**CITY OF NOVI CITY COUNCIL
JANUARY 22, 2024**

SUBJECT: Consideration for tentative approval of the request of Wixom Road Development, LLC, JSP22-01, for a Planned Suburban Low-Rise (PSLR) Overlay Development Agreement Application and Concept Plan for the Camelot Parc development. The subject property is approximately 8.78 acres of land located on the east side of Wixom Road, north of Eleven Mile Road, in Section 17. The applicant is proposing 46 units in three 2-story apartment buildings. The subject property is currently zoned R-1, One Family Residential, with a Planned Suburban Low-Rise Overlay.

SUBMITTING DEPARTMENT: Community Development - Planning

Figure 1

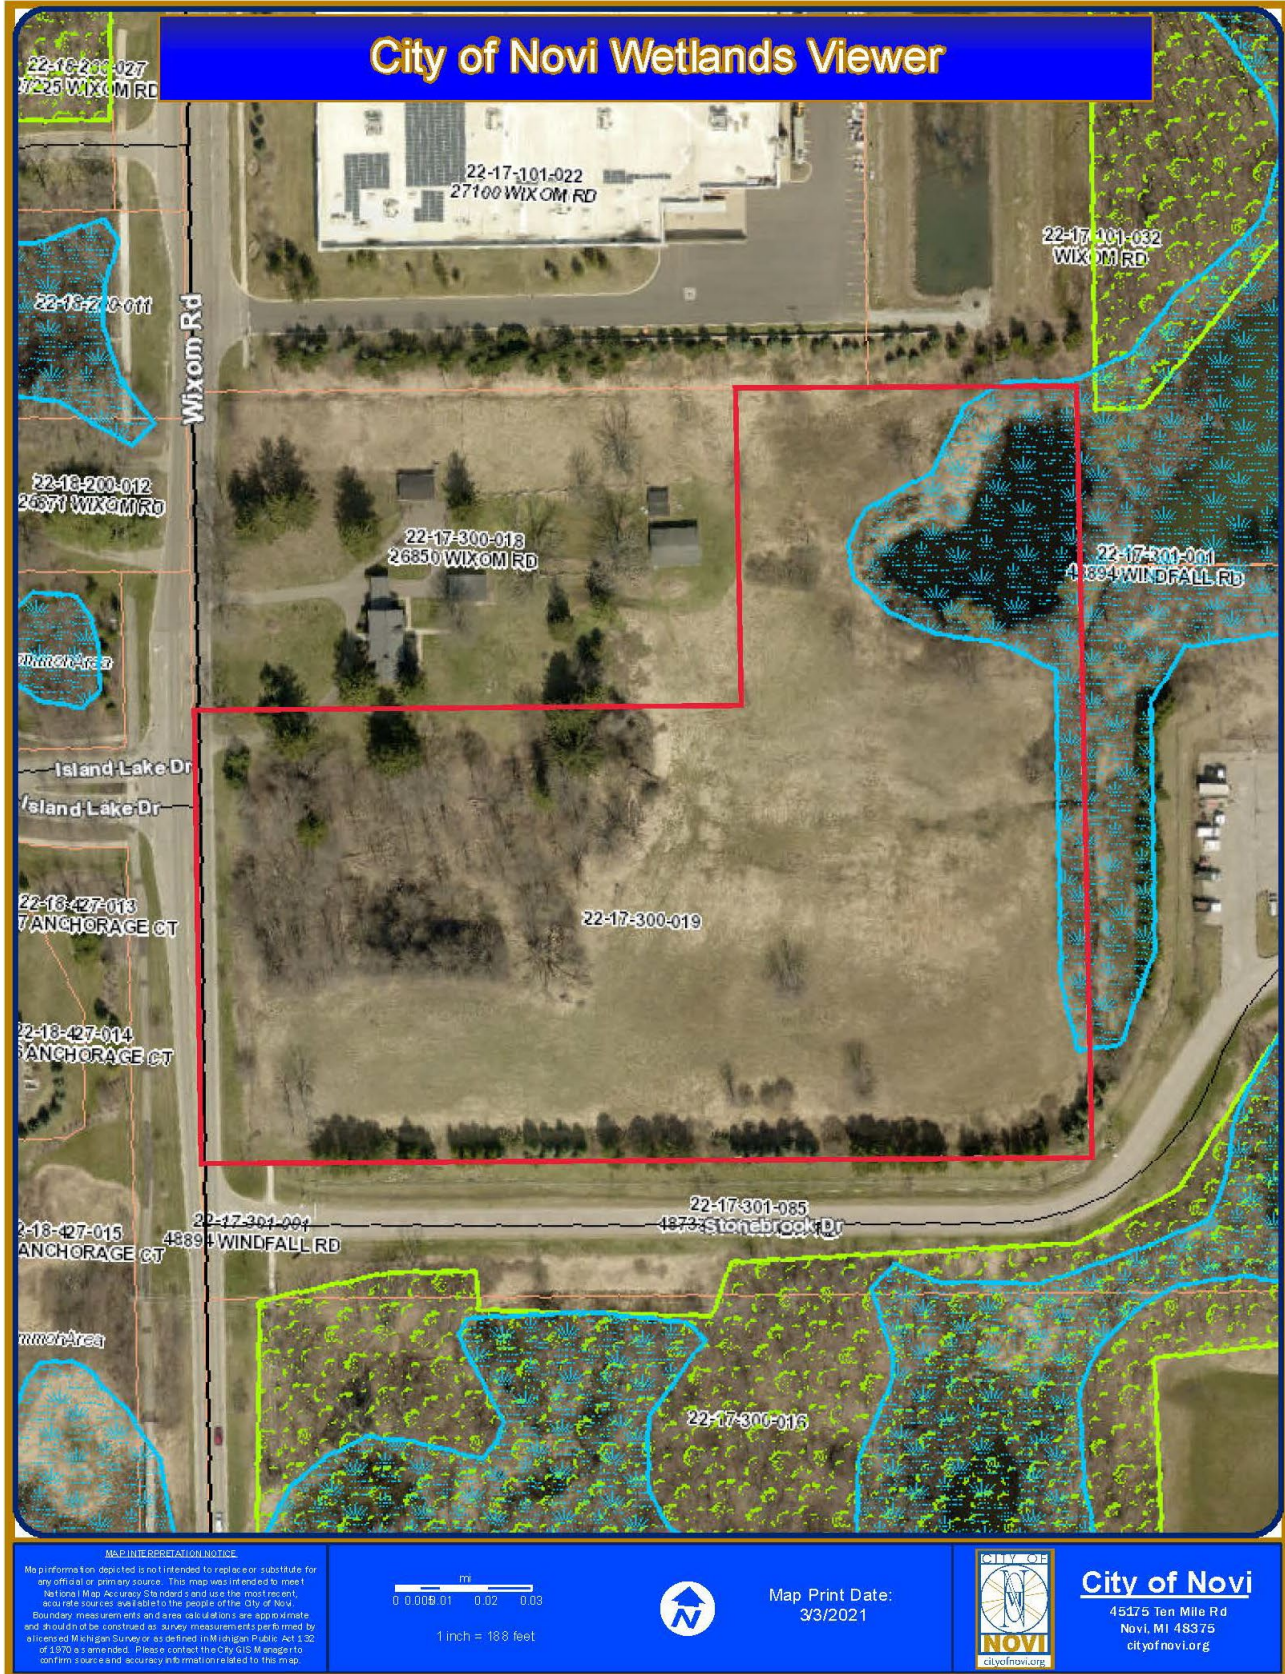
- City-regulated wetlands, as identified on the City of Novi Wetlands interactive map website. Note that both wetland and property limits depicted on the City's map are considered approximations (Figure 1).
- Wetlands that are regulated by the Michigan Department of Environment, Great Lakes, and Energy (EGLE). See the Permits and Regulatory Status section below.
- Wetlands as identified on National Wetland Inventory (NWI) and Michigan Resource Inventory System (MIRIS) maps, as identified on the EGLE Wetlands Viewer interactive map website (Figure 2). NWI and MIRIS wetlands are identified through interpretation of topographic data and aerial photographs by the associated governmental bodies.
- Hydric (wetland) soil as mapped by the U.S. Department of Agriculture, Natural Resource Conservation Service, as identified on the EGLE Wetlands Viewer interactive map website (Figure 2).
